**ENGINEERING CHANGE BULLETIN # 10014**

**.156” Pitch Male Connector Design Improvement**

**Date Effective:** 10/29/12

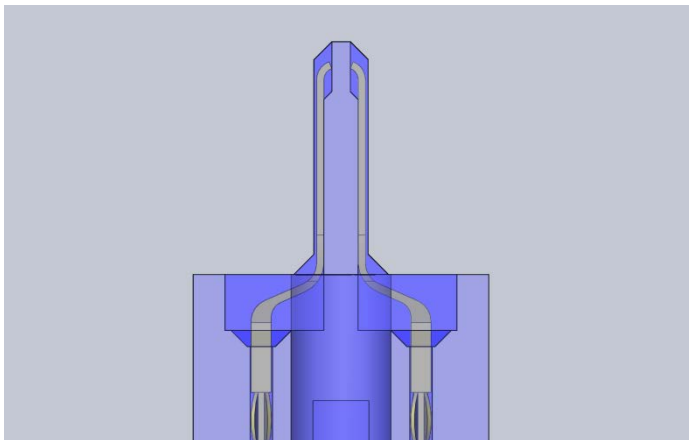
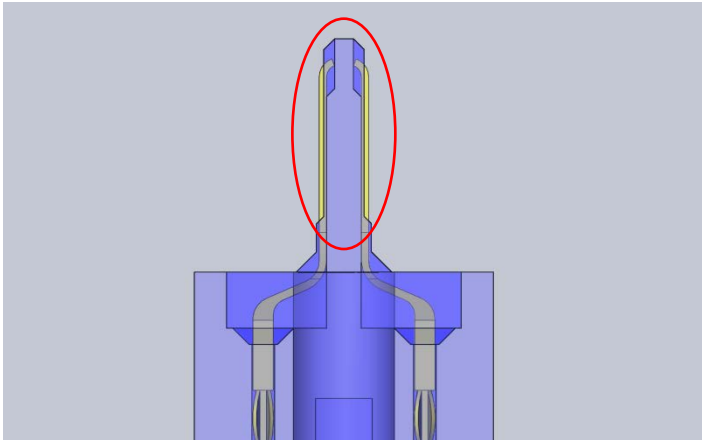
Removed plastic material that projected above contact area to improve mating contact resistance and to eliminate the possibility of intermittent contact between male and female connectors.
